Amendments to the Drawings

The attached replacement sheets of drawings includes changes to FIGS. 1 and 3 and replaces original sheets 1, 2, and 3 with replacement sheets 1 and 2.

FIG  
3

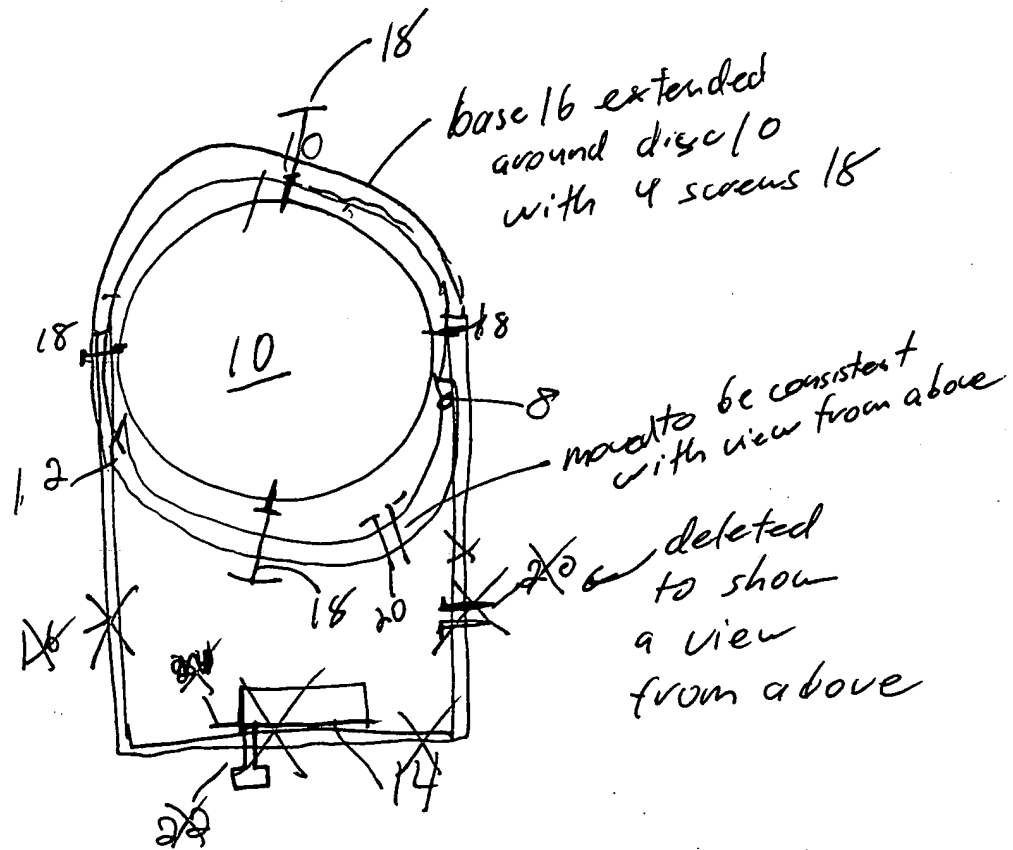
In FIG. 3:

the top portion has been amended to show a view from above the alignment fixture. In particular, base 16 has been shown with all four screws 18 joining disc 10 to base 16 as described, e.g., in paragraph [0026]. Further, the portions of the alignment fixture and detector or chip 14 described as below disc 10 (e.g., in paragraphs [0026] and [0027]) have been deleted; and

the bottom portion has been amended to show a cut away side view of the alignment fixture in a commercial aligner 26 as described, e.g., in paragraph [0029]. Further, thumb wheel 22 and vacuum inlet 20 (as shown in the top portion of FIG. 3) have been added, and lines have been deleted to ensure that aligner 26 is distinguished from base 16.

In FIG. 3, the top portion has been amended to show a view from above the alignment fixture. In particular, base 16 has been shown with all four screws 18 joining disc 10 to base 16 as described, e.g., in paragraph [0026]. No new matter has been added.

Also in FIG. 3, the bottom portion has been amended to show a cut away side view of the alignment fixture in a commercial aligner 26 as described, e.g., in paragraph [0029]. Further, thumb wheel 22 and vacuum inlet 20 (as shown in the top portion of FIG. 3) have been added. No new matter has been added.
